PCN Title	Mako G surface treatment change to black powder coating		
Affected Products	Mako G camera family		
PCN Number	PCR-2017-03-05	PCN Issue date	2017-July-20 Updated Dec. 04
Contact	Inside Sales Team

All Mako G camera models and modular concept options

Mako with silver nickel plating surface
Mako with black powder coating surface

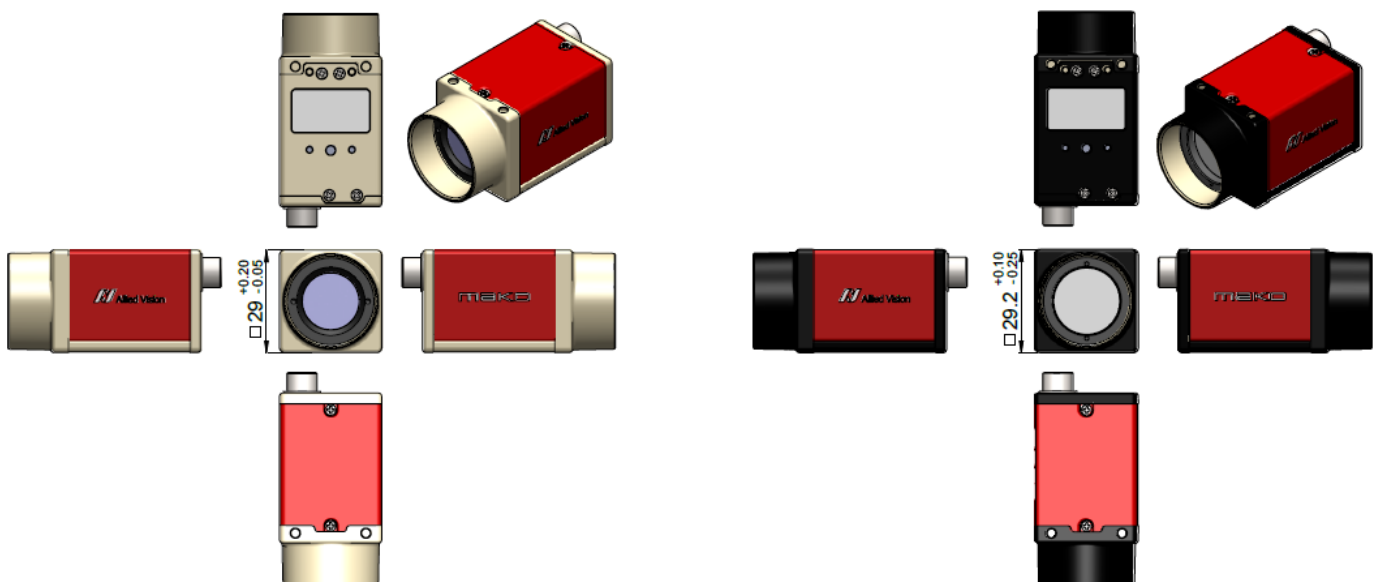
The Mako housing (back plate, bottom plate, and front flange) surface treatment will be changed from nickel plating to black powder coating. The change is cosmetic and will not have a negative effect on the image quality or camera performance. There are a slight dimension increases (<0.2 mm), see Figure 1 and Figure 2 below for a detailed comparison of the legacy and new finishes.

Figure 1 – Front flange dimension of old silver nickel plating vs. new black powder coating

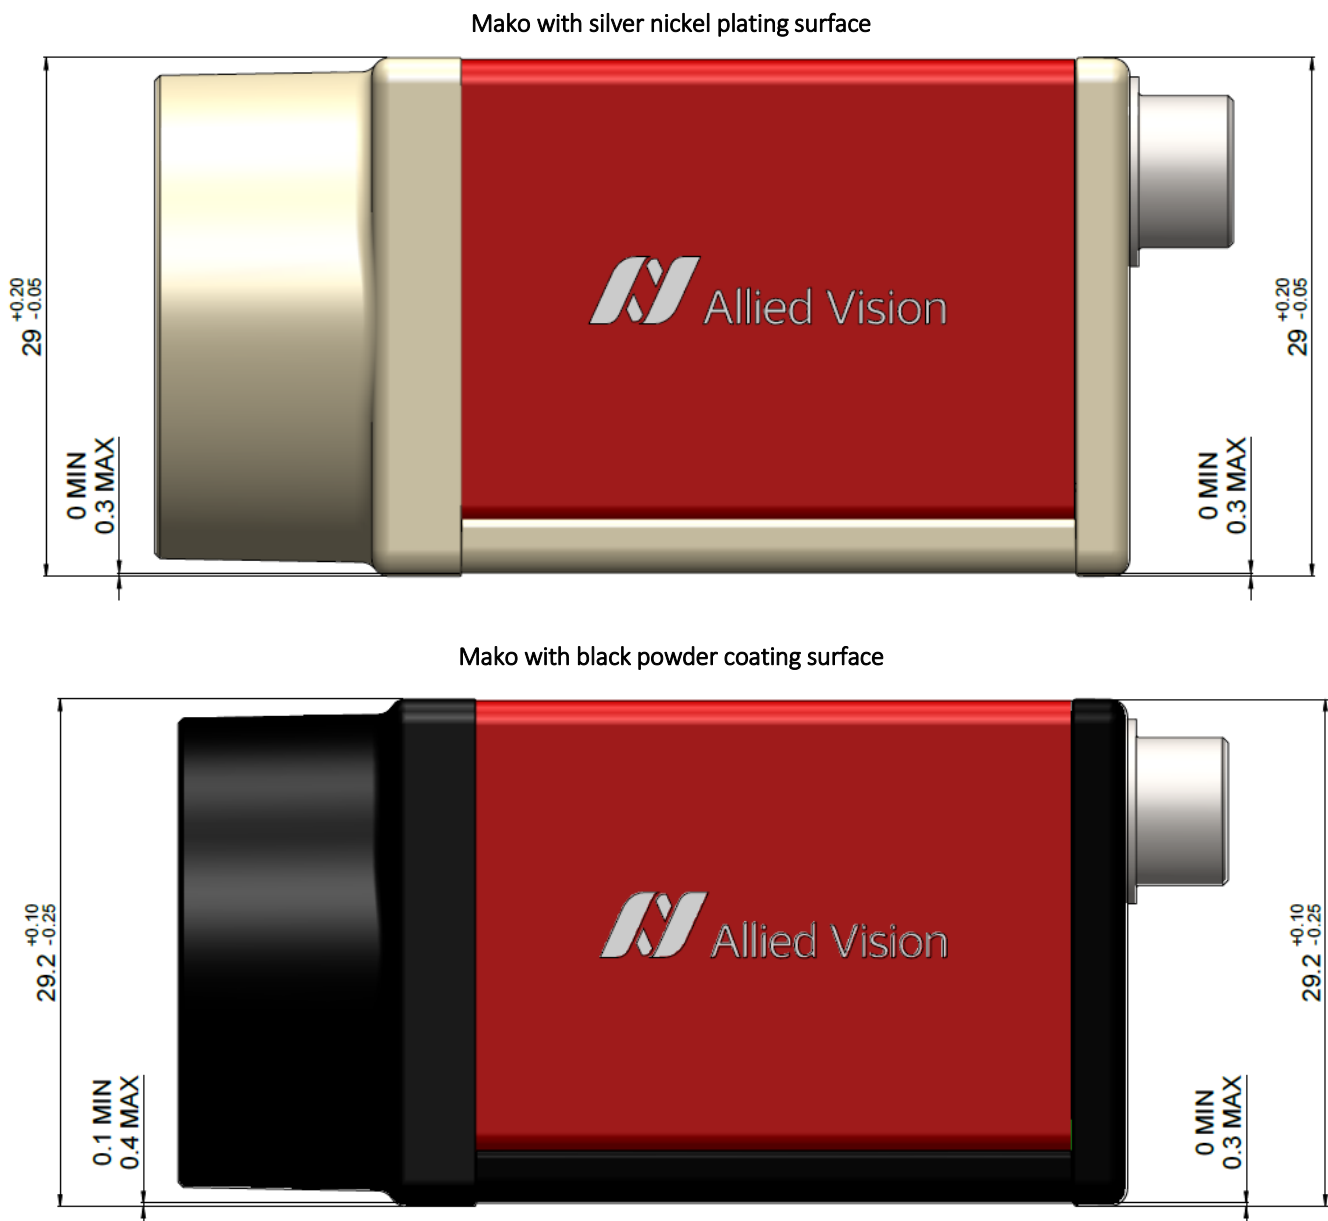
This housing change is effective from SN 536905675 onwards.
